Project
Canberra Labor Club Belconnen Hotel
Blocks 20 Section 48 Division Belconnen

Drawing Title
West Elevation

**RESPONSE TO FURTHER INFORMATION REQUEST – STRATEGIC PLANNING UNIT COMMENTS:
DA201630289: BLOCKS 8 AND 9 SECTION 48 BELCONNEN**

Attachment A – Alternative Façade Treatment to Hotel Podium

Job No.	Drawing No.	Scale	Rev.
16_35	S197-A201A	1:100@A1	D

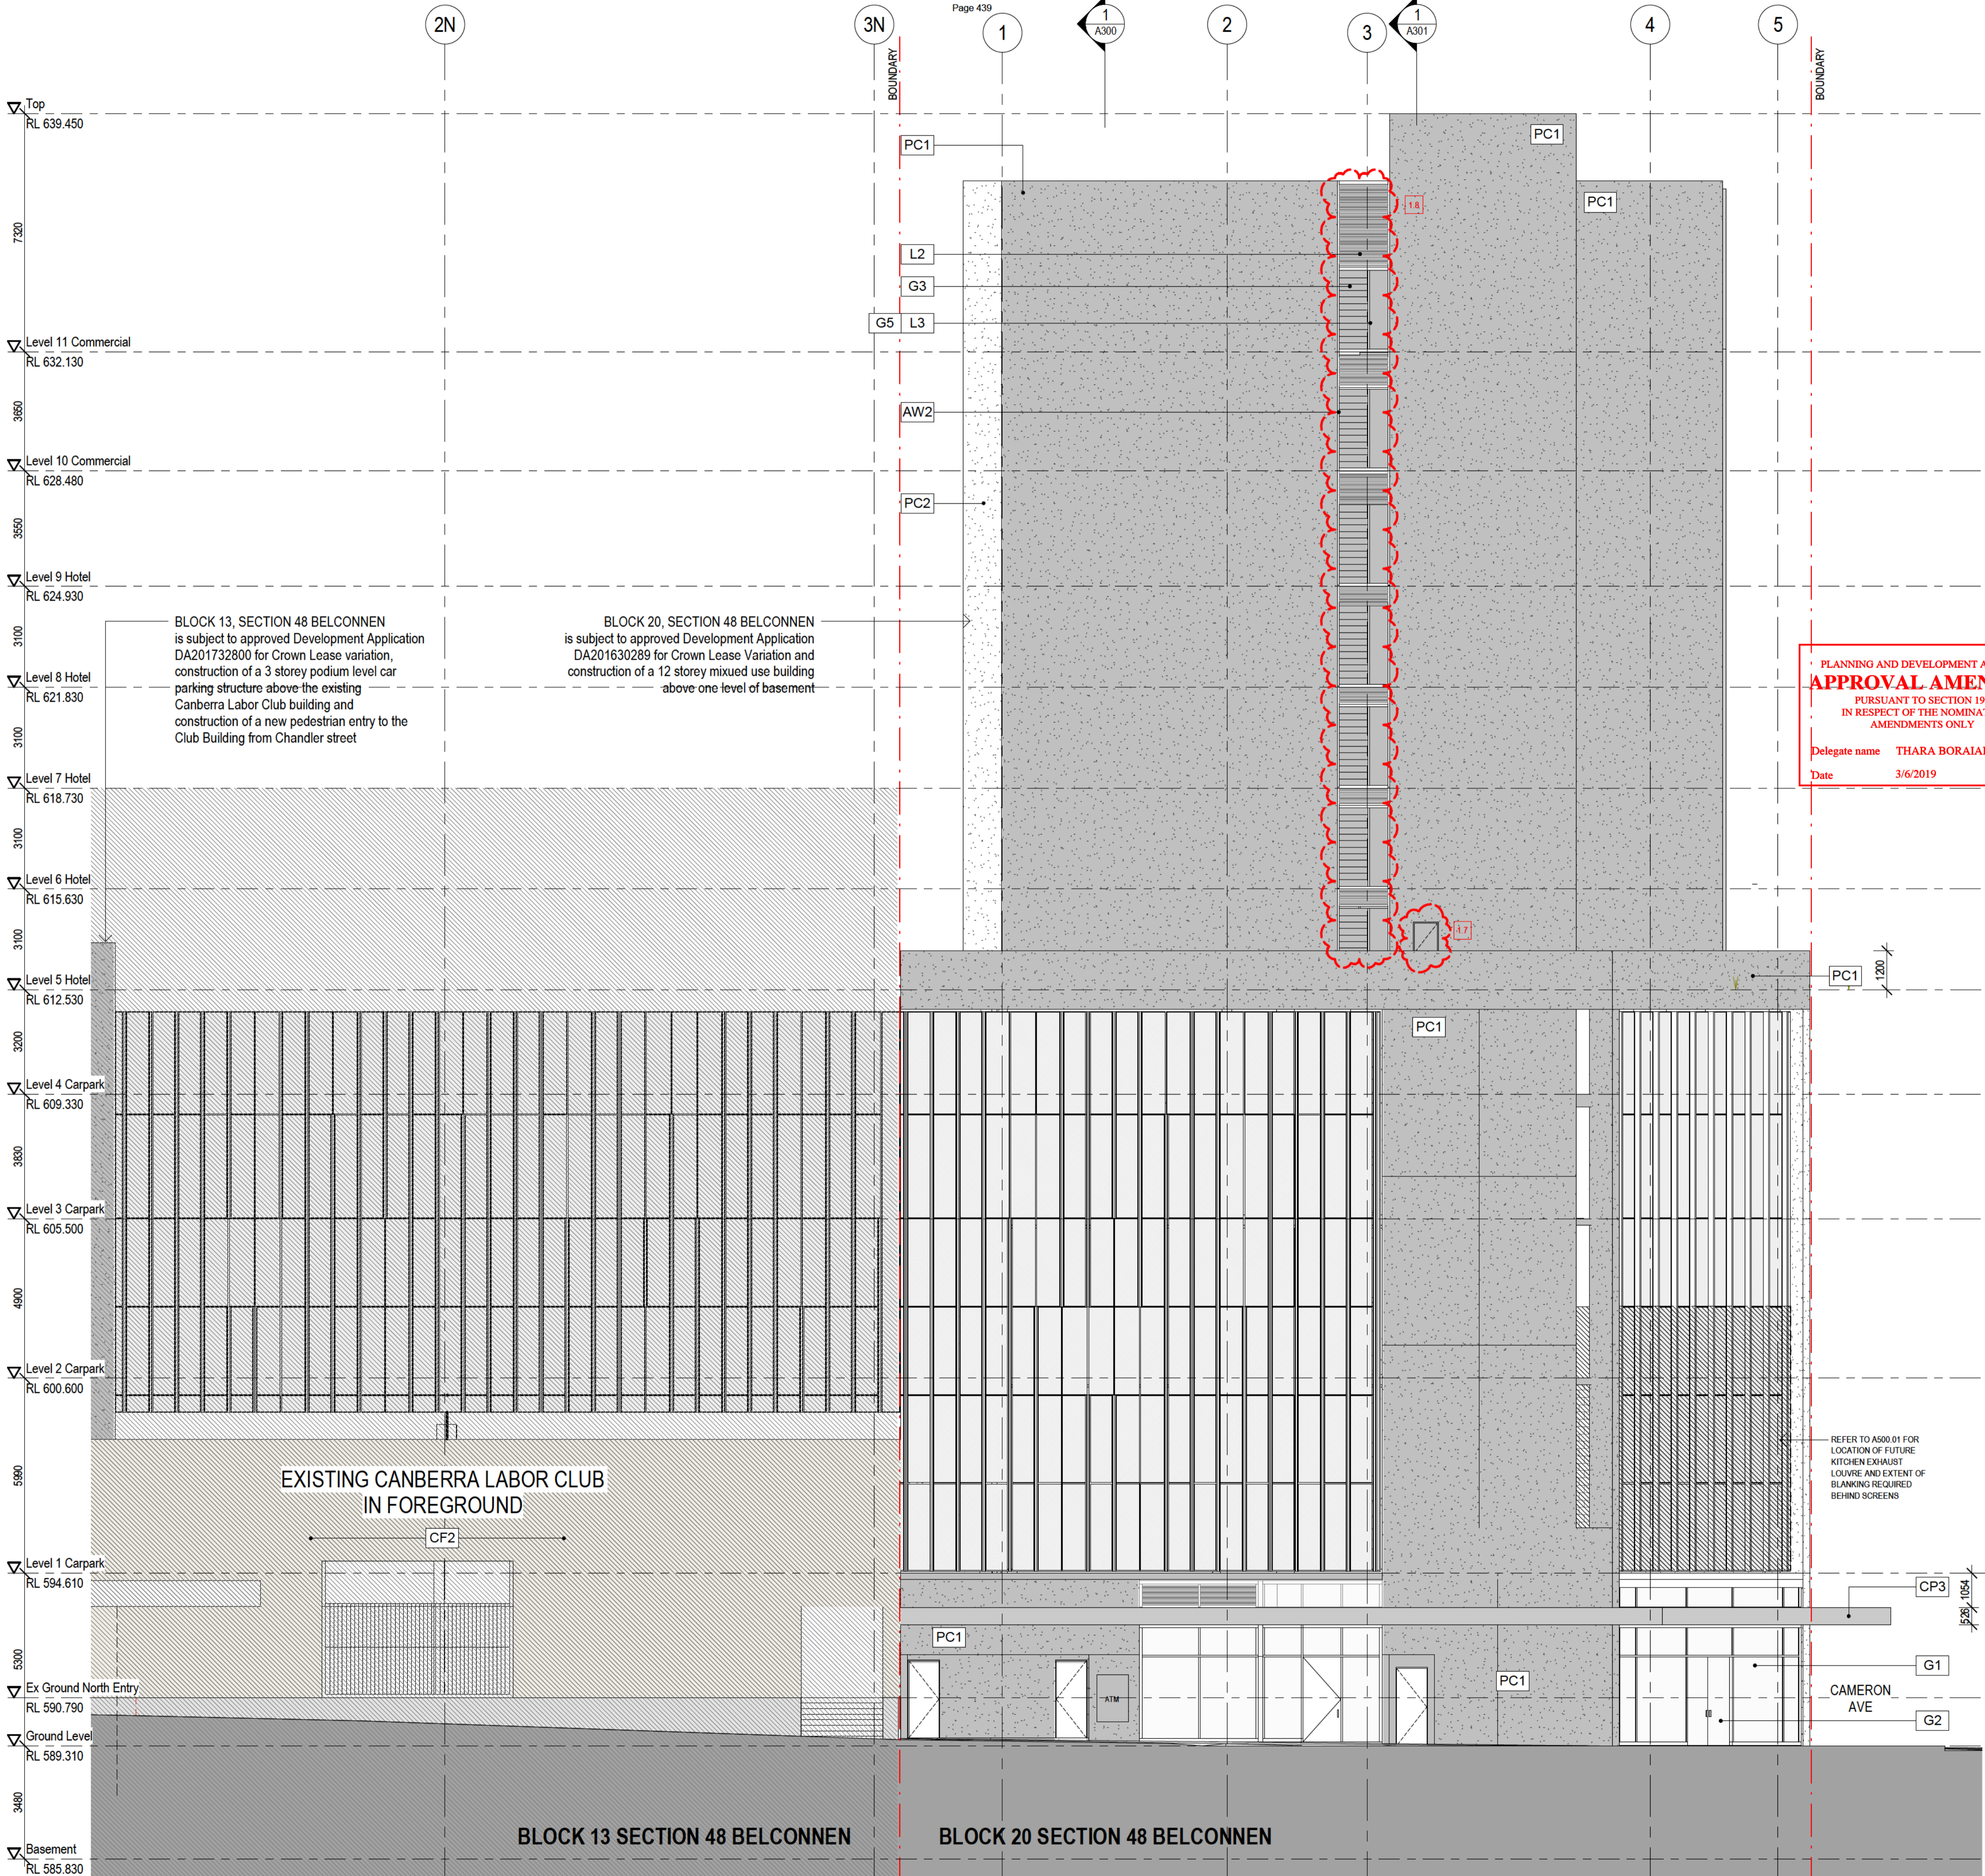
S197 DA Amendment Legend	
1.1	Courtyard removed and built in - GFA increase
1.2	NOT USED
1.3	NOT USED
1.4	Comms room size increased
1.5	Hotel interconnecting door deleted
1.6	Hotel room layout revised
1.7	Level 5 rooftop access provision added
1.8	Louvre / glazing condition revised
